| From: | personal bhjv.com.au <no-reply@bhjv.com.au></no-reply@bhjv.com.au> |
|--------------|--|
| Subject: | CN-11843 RFI-0357 [Existing Energex conduits near subgrade MC1L20 CH125] |

| REQUEST FOR INFORMATION | | | | | | |
|---|---|--|---|--|---|-------------------------|
| Contract Name: | Watland Street to | Sports Drive | | | | |

| RFI BODY | |
|------------------|--|
| RFI Description: | Existing asbestos Energex conduits have been exposed 37-83mm below subgrade at MC1L20 CH125. The conduits were identified as E-13 in the 1PU10 drawing set. Refer to attached markup and photos for details. The position and material of the conduits will restrict our ability to compact the existing subgrade material and the pavement directly above them. Please advise how to proceed. |

Drawing No. 839123 A Series Number PU-3007

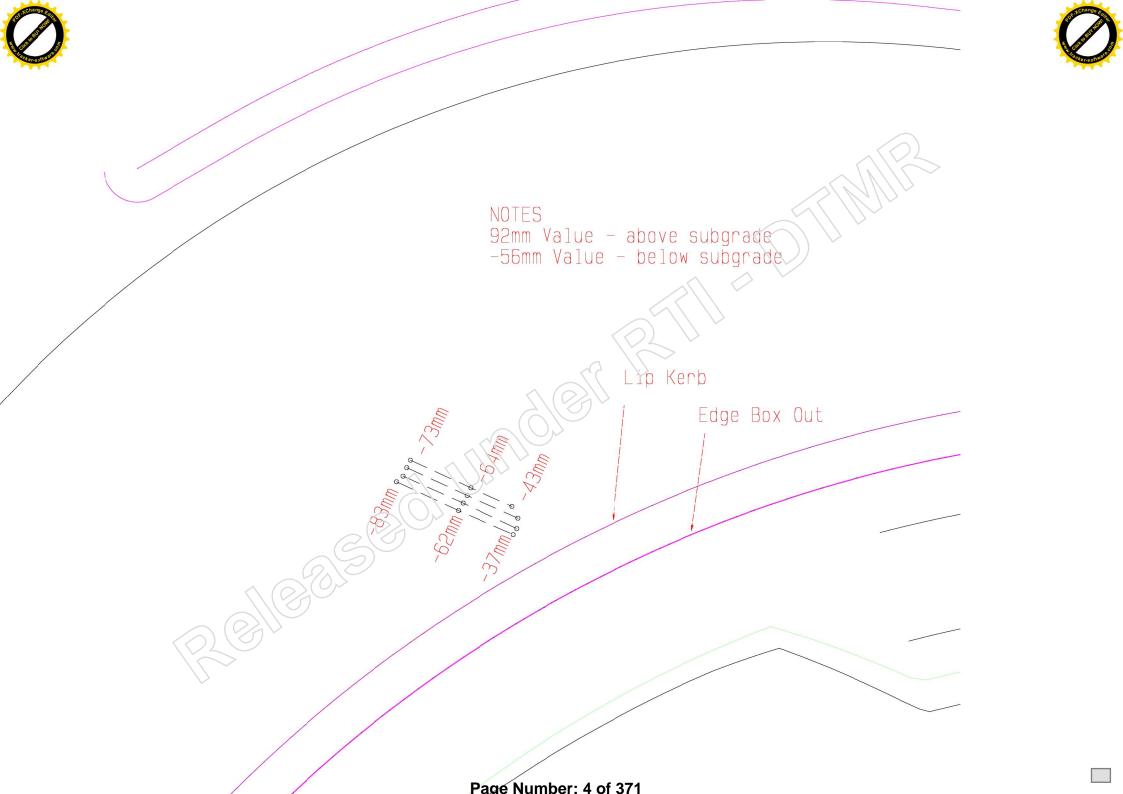
| RFI BODY | |
|------------------|--|
| RFI Reason: | Confirm treatment required to existing conduits or subgrade/pavement around shallow asbestos electrical conduits. |

respect of 2.3 star "Catator of the second o No subgrade treatment shall be applied to the top of conduits, and no vibration on roller to be applied until sufficient cover is achieved, noting the scope for E-13 is for "Contractor to provide temporary protection during construction works". Remaining pavement construction to proceed as normal.

applied until sufficient cover is achieved, noting the scope for E-13 is for "Contractor to provide temporary protection during construction works". Remaining pavement construction to proceed as normal.

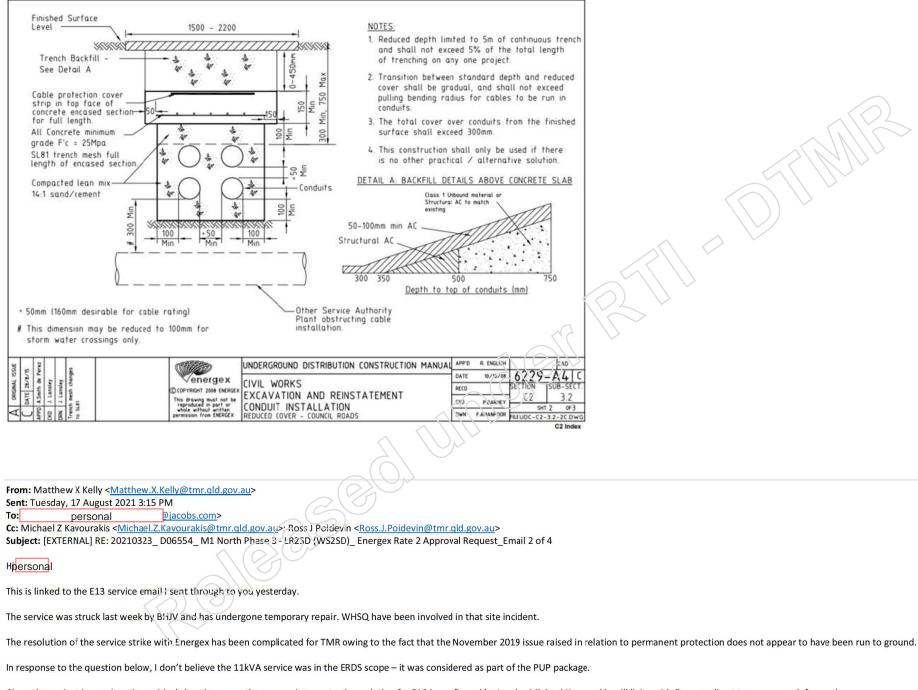
As per the attached Longitudinal Section 24012A4.3-JEG-1PU10-SKT-9002, there is a short length of pavement widening where we approach the requirement of the 750mm cover to conduits that require protection as per Energex standard drawing 6229-A4. Our minimum cover

Is 737 mm so its only just meeting the requirement for protection. For the remainder of the longitudinal section, cover is 1.0m or greater

ENERGEX SERVICE PROTECTION STRUCTURE AT COMPTON RD - TYPICAL CROSS SECTION

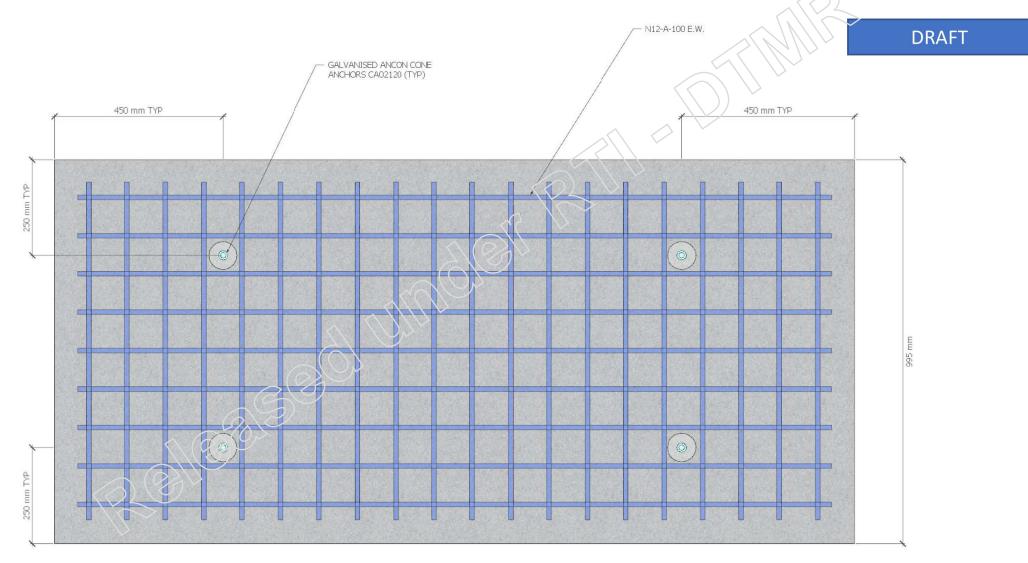
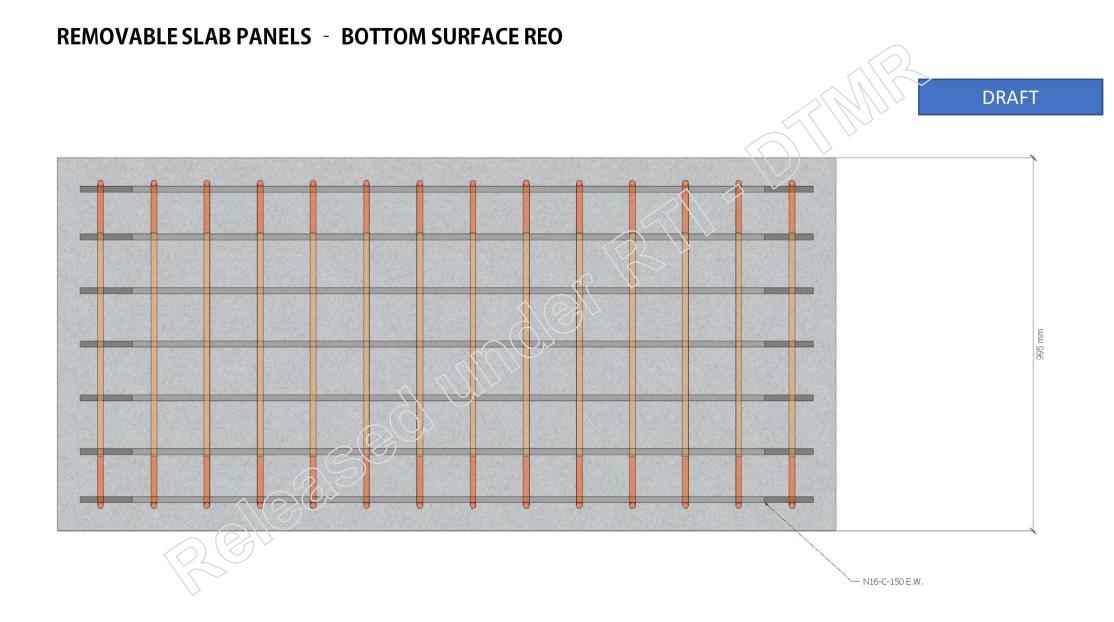
- 1. Installation of protection slab in accordance with Energex Standard Drawing 6229-A4 (attached).
- 2. Length of slab to be determined on site, based on extent of substandard cover. We anticipate that the extent of protection will be approximately 6 or 7 metres from the new kerb however it might be safer to wait for confirmation effective maticipate that the extent of protection will be approximately 6 or 7 metres from the new kerb however it might be safer to wait for confirmation effective maticipate that the extent of protection will be approximately 6 or 7 metres from the new kerb however it might be safer to wait for confirmation effective maticipate that the extent of protection will be approximately 6 or 7 metres from the new kerb however it might be safer to wait for confirmation effective maticipate that the extent of protection will be approximately 6 or 7 metres from the new kerb however it might be safer to wait for confirmation effective maticipate that the extent of protection will be approximately 6 or 7 metres from the new kerb however it might be safer to wait for confirmation effective maticipate that the extent of protection will be approximately 6 or 7 metres from the new kerb however it might be safer to wait for confirmation effective maticipate that the extent of protection will be approximately 6 or 7 metres from the new kerb however it might be safer to wait for confirmation effective maticipate that the extent of protection will be approximately 6 or 7 metres from the new kerb however it might be safer to wait for confirmation effective maticipate that the extent of protective matici

- Jacobs have reviewed the standard Energex drawing 6229-A4 as per the below which incorporates compacted lean mix within the trench with a concrete slab over. •

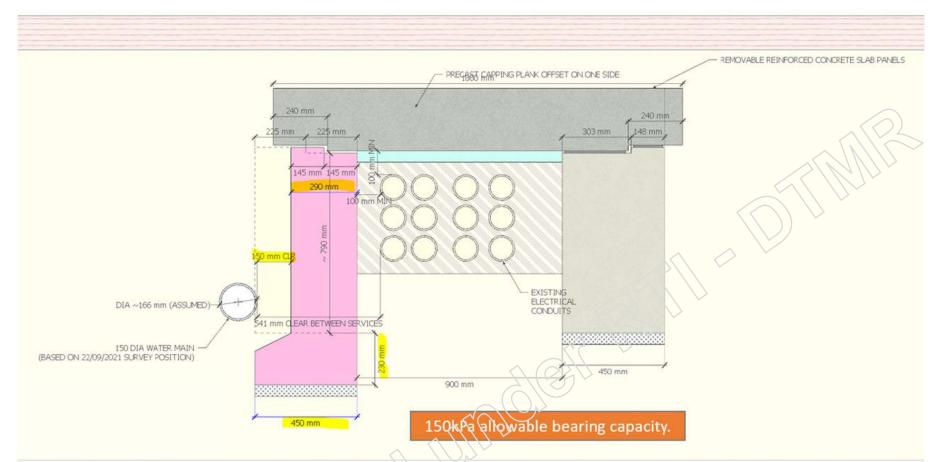
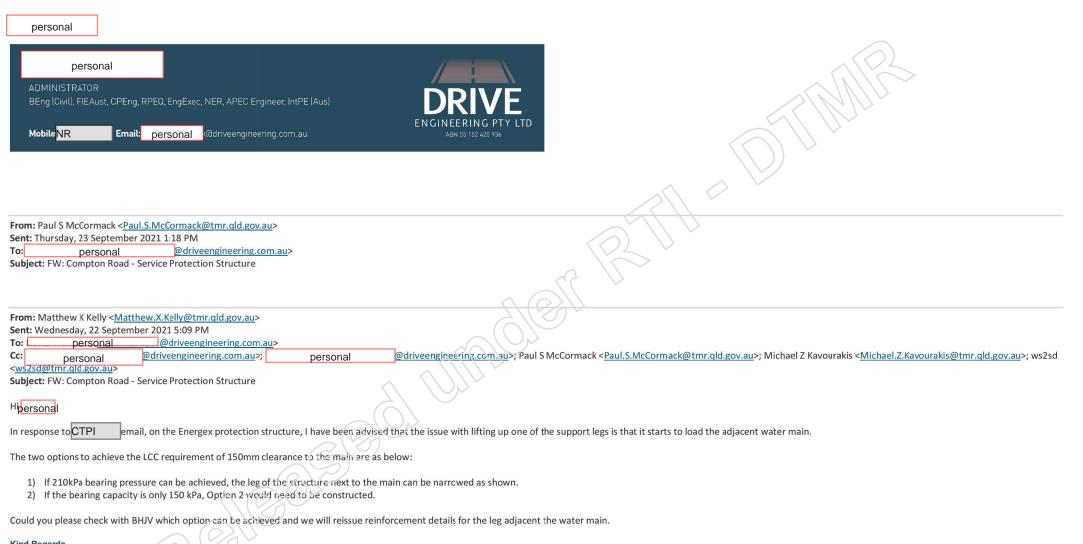
To maintain the (verbally advised) 150kPa allowable bearing capacity, the base of the footing can be flared out to 450mm wide beneath the water main. The issue with this is it involves a deeper excavation and also undermines the water main and/or HV electrical conduits. These services would clearly require some temporary support during construction and there is significant risk of damage. **OPTION 2: ~150kPa ALLOWABLE BEARING PRESSURE - NARROWER FOOTING FLARED TO 450MM WIDE BENEATH WATER MAIN**

I also understand the precast RC lids have / are current in fabrication. Aligning the edge recesses in these planks to the upstands on the footings might need a little modification of the footings and overhang of the precast panels, so treat the above as indicative of the concept until I can get the adopted recess dimensions.

As discussed, TMR have gone back to Jacobs and have come up with the following two options for the protection slab support legs.

ENERGEX SERVICE PROTECTION STRUCTURE AT COMPTON RD – PLAN

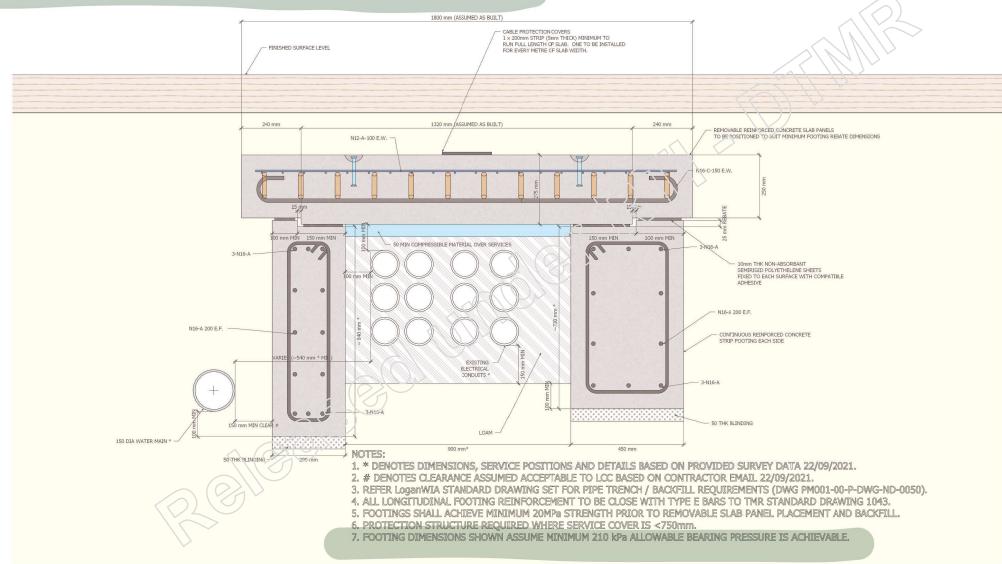
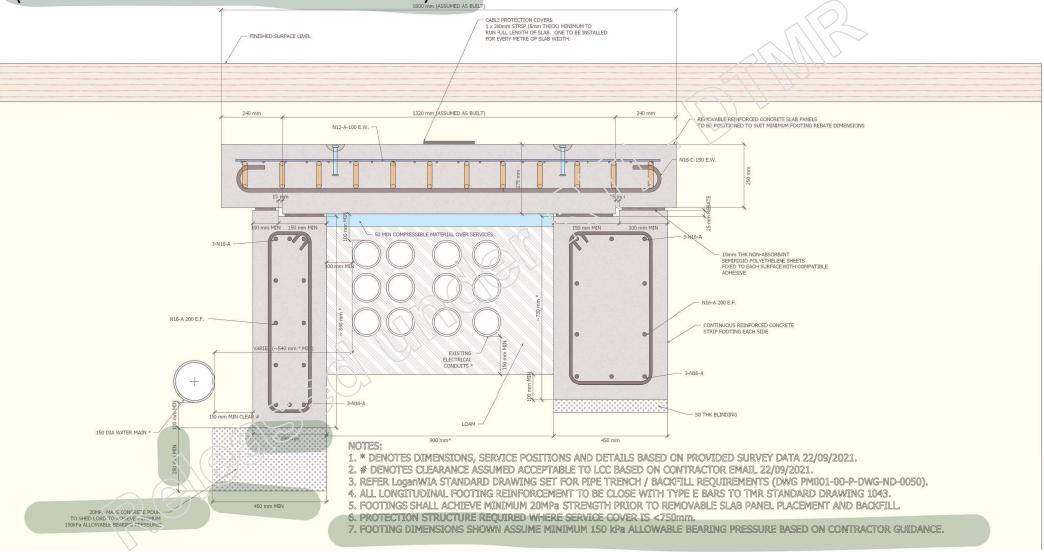
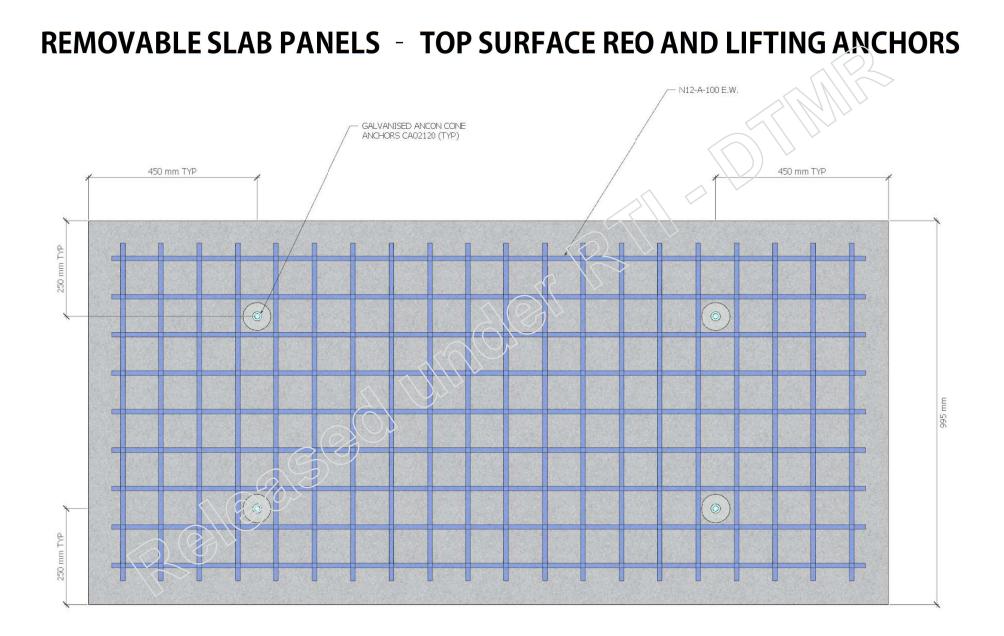
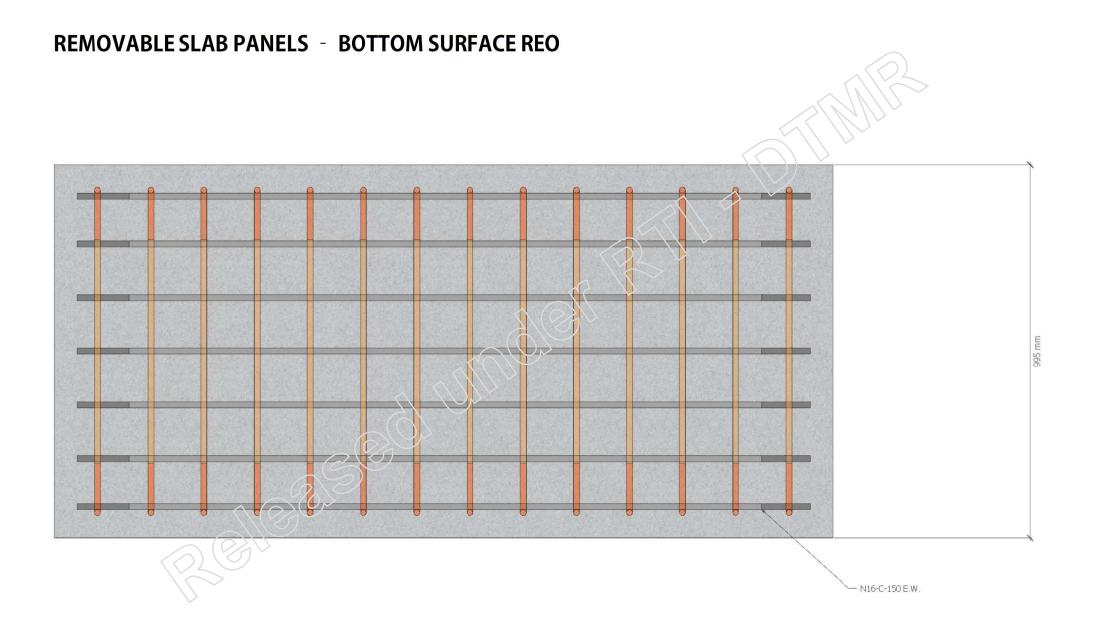
Further to the correspondence below, please provide a revised reinforcement detail for Option 1 on the assumption that 210kPa is achieved.

We can make both options below work, If we don't achieve 210Kpa, we can excavate the thickening and replace with mass concrete back to the revised footing.
